MEMORANDUM

Date: February 26, 2016
To: Water Right File 65-22979 and 65-23479
From: A. Newbry
Re: Dam Safety Site Visit

TRIP REPORT

TO: Nick Miller, Western Region Manager
CC: Erik Boe, Ashley Newbry, Jeff Peppersack
FROM: John Falk, PE
DATE: February 26, 2016
SUBJECT: Dry Creek Diversion Dam
IDWR File: 65-7603 (65-23479 enlargement)

Photo 3 – Similar view illustrating the source of rivulets and deposited soil at the toe of the slope.
Dry Creek Diversion Dam

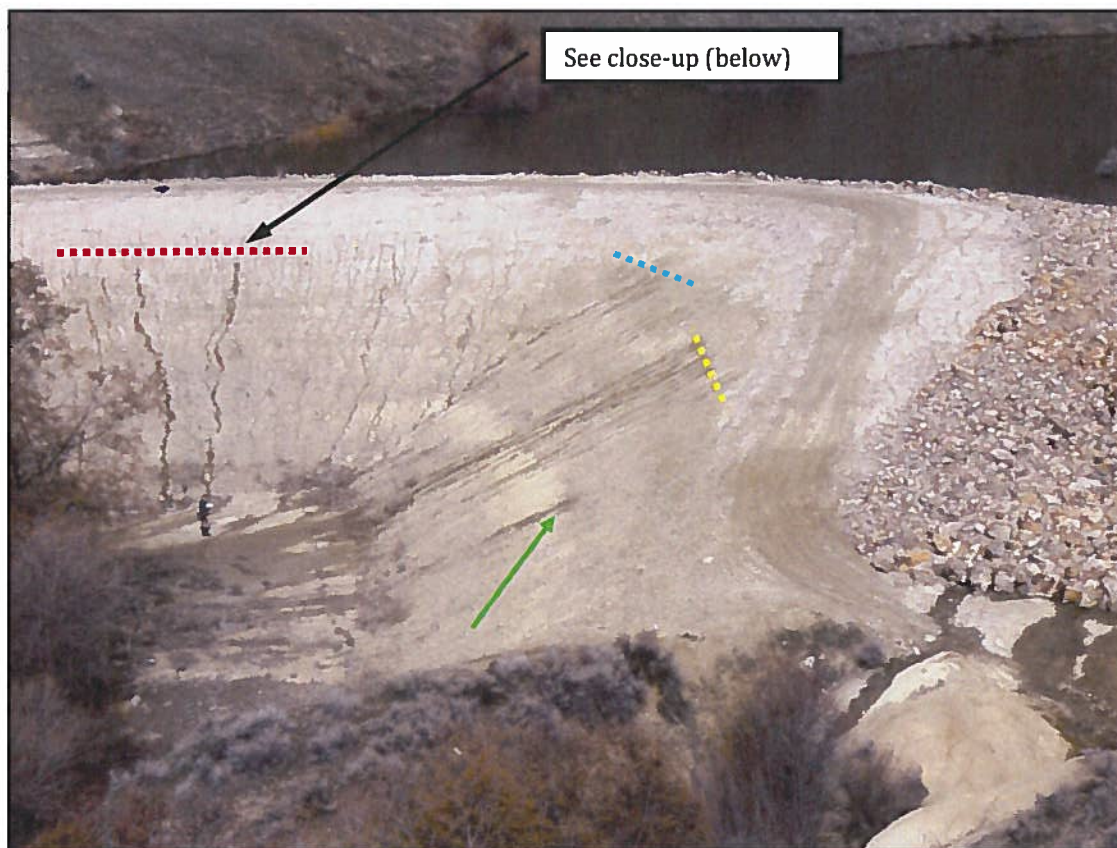
At the Diversion Dam, we observed multiple rivulets at randomly spaced locations across the downstream slopes of the earthen embankment; including several that were flowing measureable quantities of water. The larger source of the water supplying the rivulets likely originates from the reservoir impounded behind the diversion dam. The flow of water was confined to narrow rills which appeared to have been eroded into the earthen soils by the force /velocity /duration of the flow. Of all dozen or so flowing rivulets observed, the greatest flow was estimated to be 2 gallons per minute (Photo 5).

Further, the uppermost elevation of the rivulets appeared to have a common upper lineal boundary; i.e. the appearance of flow was associated with a horizontal feature, band or layer within the mass of the embankment (Photo 3). The lower portions of the exposed embankment slope were dry except in, or immediately adjacent to, the channels (rills) created by the rivulets. Discharge from the toe drain was significantly less than the sum of the leakage flowing from the rivulets. Such observations suggest that the embankment is not saturated, and that the phreatic line does not daylight high on the slope. An explanation for the numerous rivulets may be the result of a permeable layer of material that was introduced during construction of the embankment, or perhaps due to improperly compacted layers of fill materials in the dam.

Regardless the causes for the multiple leaks witnessed on the exposed slope of the Diversion Dam any appearance of seepage, and especially that of *flowing water*, located anywhere on the downstream face of an earthen dam is reason for concern. Without undue delay, the owner must begin lowering the level of the reservoir to an elevation that results in stoppage of all observed leakage. In the interim, the dam owner and his engineer should begin making necessary arrangements to investigate and positively identify the source of the leak(s). Once identified, the embankment must be repaired in a manner that results in satisfactory resolution of this observed deficiency. Failure to make adequate repair and/or to lower the pool level in a timely manner may result in catastrophic breach of the embankment. The storage certificate for the Diversion Dam expires at the end of the year, 12/31/2016; its existing status and future renewal should be dependent on whether or not this problem is resolved.

Figure 1 (left) – Reprint from Record Drawings, Sheet C301 illustrating the cross-section of the concrete overflow spillway along the center-line axis. Note the view is in the direction of flow, downstream convention (left = east).

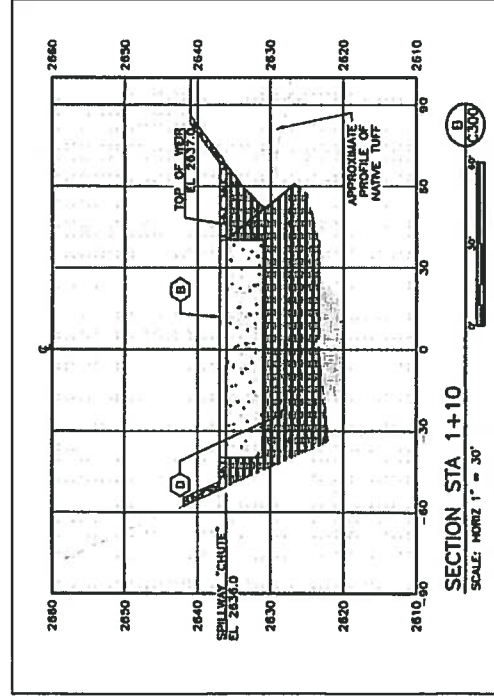
Pool Level @ Diversion Dam: 2637.0 feet - 0.875 feet (10-1/2 ") = ±2636.13 feet
 Toe Drain Invert: ±2602 feet (estimated from record drawings)
 * Stationing referenced to Record Drawings, Sheet C301

Figure 2 - Copy from Record Drawings-Sheet C300, showing approximate locations of rivulets; identified per Stationing in Table 1 (see photos 2-4).

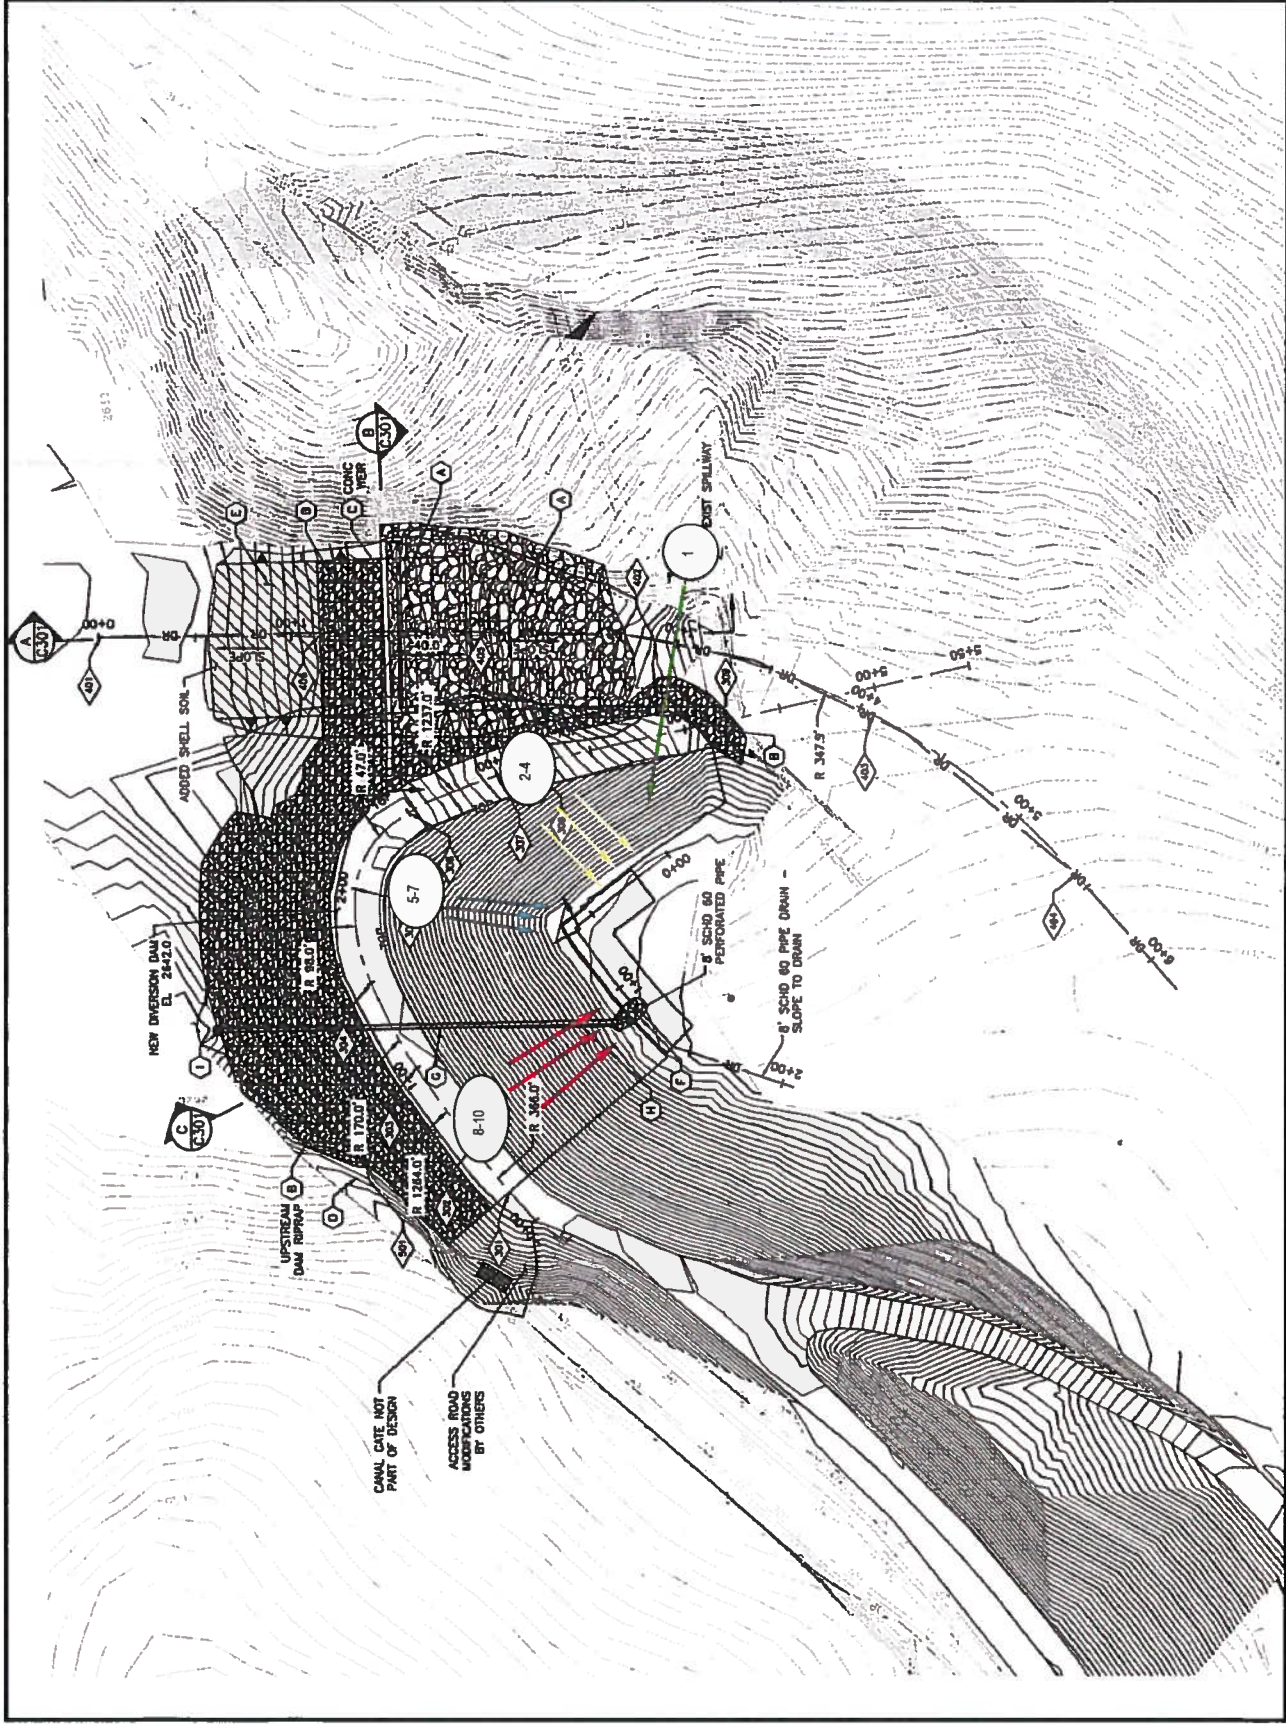
Table 1 (above) – Summary of elevation results from level-line survey performed 2/26/16. All elevations are relative to the crest of the concrete overflow spillway. Station No's 1-10 were arbitrarily assigned to identify the approximate locations of rivulets exhibiting leakage/seepage.
